ECN/PCN No.: M1177

For Manufacturer			
<b>Product Description:</b> <b>RJ45 10/100 Base-T / 1 X USB</b> <b>Combo, w/ LEDs, Ext Temp</b>	<b>Abrakon Part Number / Part Series:</b>  <b>ARJ-169</b>	<input type="checkbox"/> Documentation only <input checked="" type="checkbox"/> ECN <input type="checkbox"/> EOL	<input type="checkbox"/> Series <input checked="" type="checkbox"/> Part Number(s)
<b>Affected Revision:</b> <b>B</b>	<b>New Revision:</b> <b>C</b>	<b>Application:</b>	<input type="checkbox"/> Safety <input checked="" type="checkbox"/> Non-Safety

**Cause/Reason for Change:**

Adding additional production line. Updating graphics for datasheets.

## 7.1 DIP Wave Soldering Profile

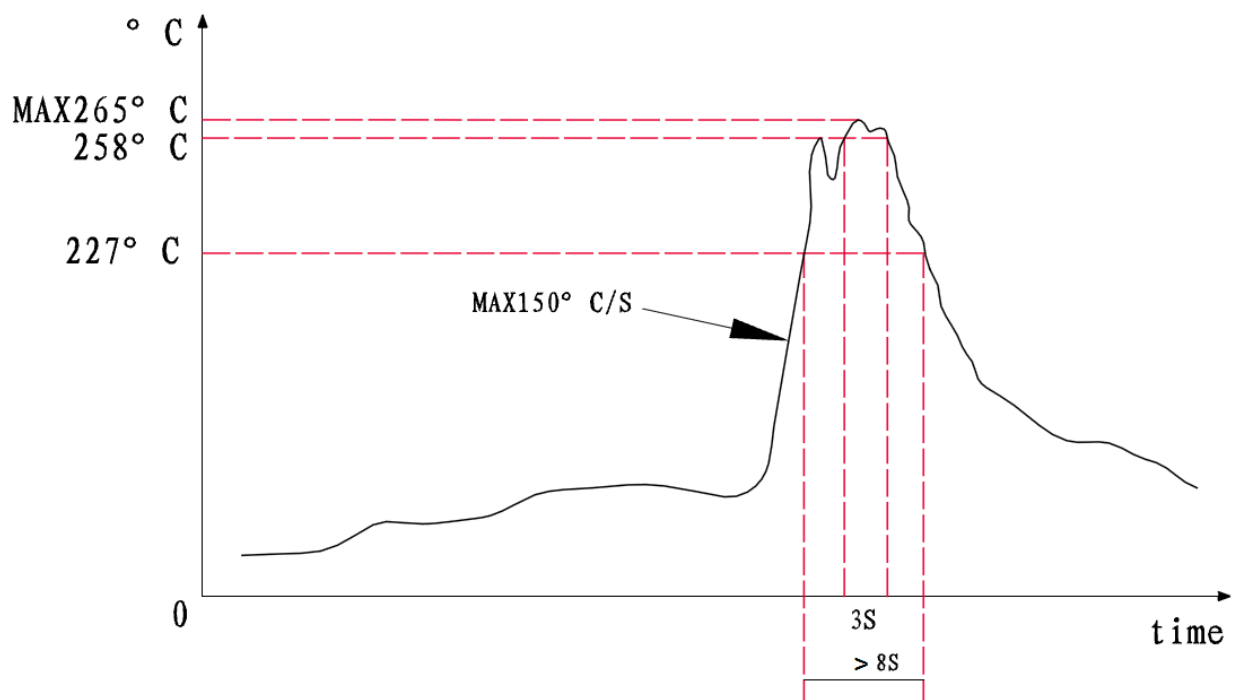
Peak temperature(Tp) : 265°C

Peak temperature(Tp) time : 3sec max

Zone	Description	Temperature	Times
1	Preheat	$T_{SMIN} \sim T_{SMAX}$ 150°C ~ 180°C	60 ~ 120 sec.
2	Reflow	$T_L$ 227°C	8 sec.
3	Peak heat	$T_P$ 265°C	3 sec. MAX

**8.0 Packing: 50pcs/tray**  
**Weight: 12.1 grams / pcs**

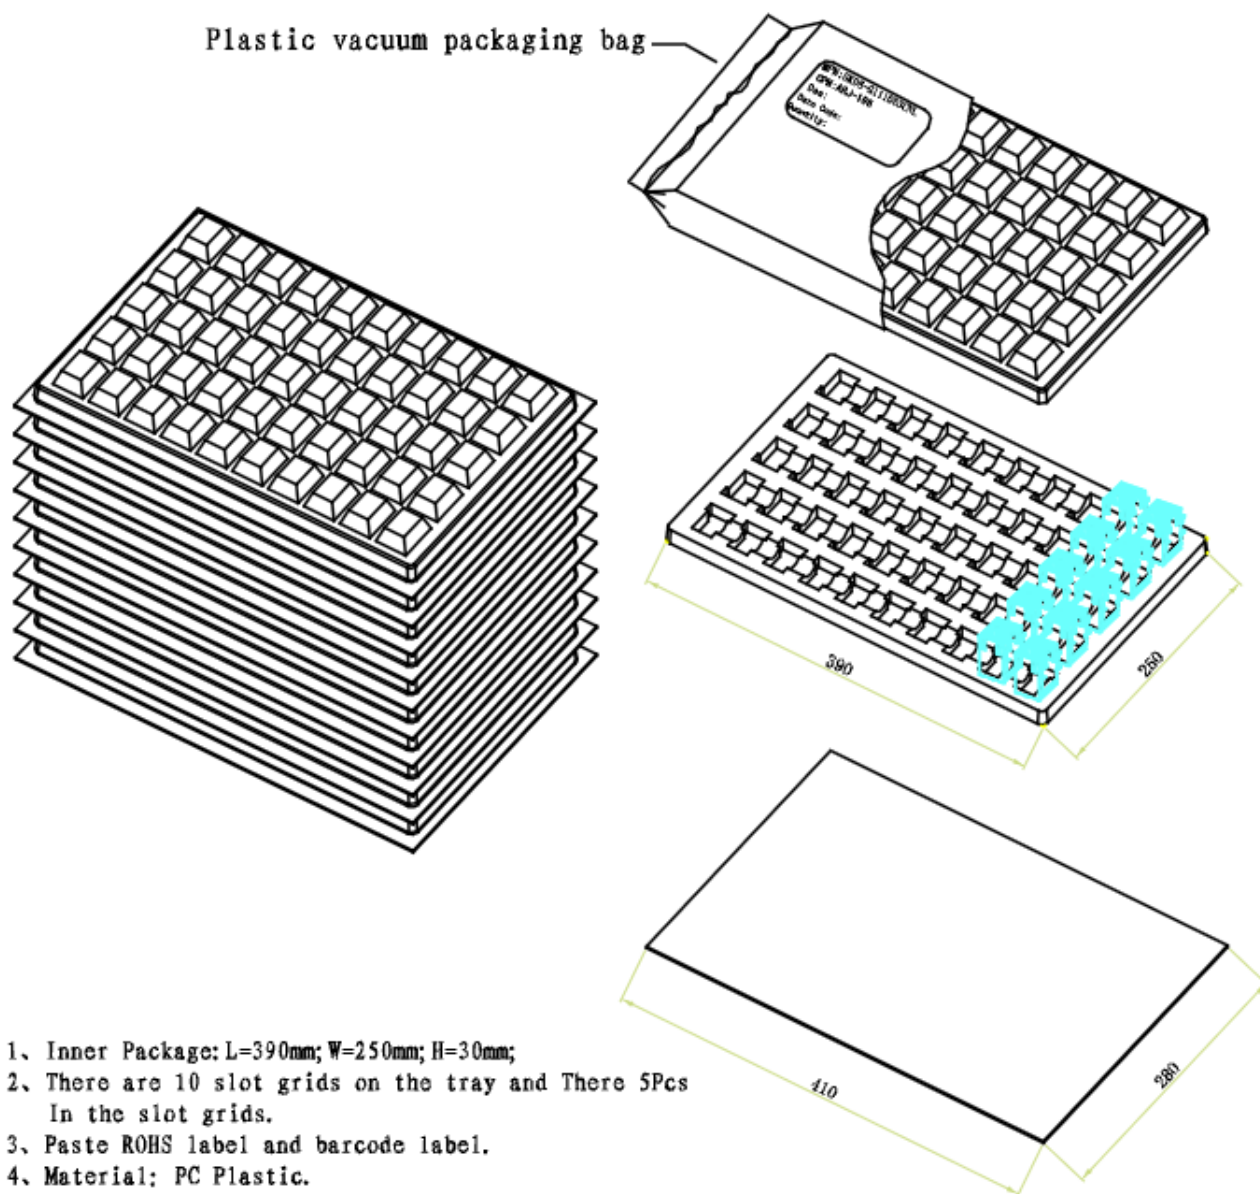
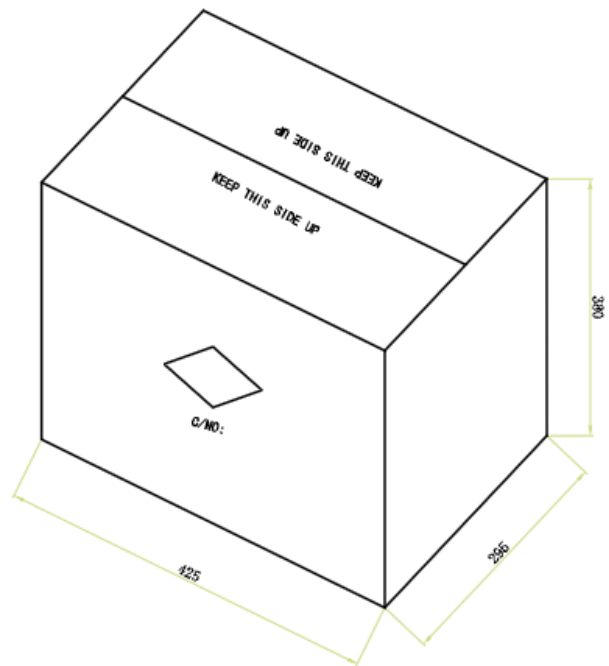
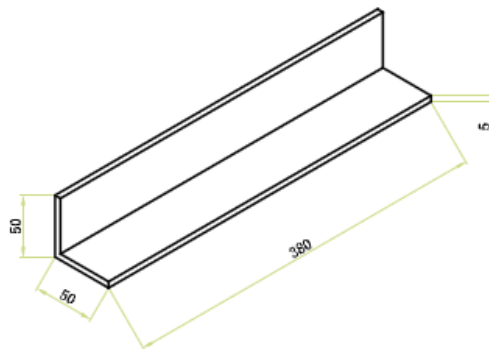
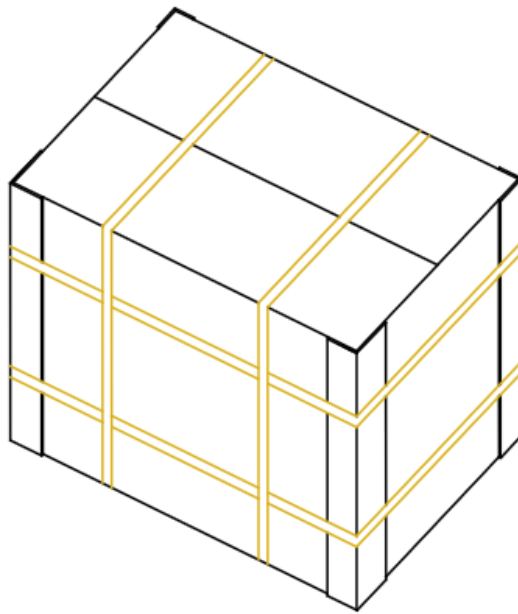
**Packing Material: PC Plastic**

Outer carton unit (optional): 500 pcs/10 trays/box

1. Package Box : L=425mm; W=295mm; H=380mm;
2. Package Box contain 10 PCS inner package Trays.
3. Material: US CARD+kraft papers.
4. There are 500 PCS products in the Package Box.

**Bulk/Tray (40pcs/tray, 16 trays/carton)**

**Carton Size : 370 X 300 X 300 mm, weight is 9.5Kg**
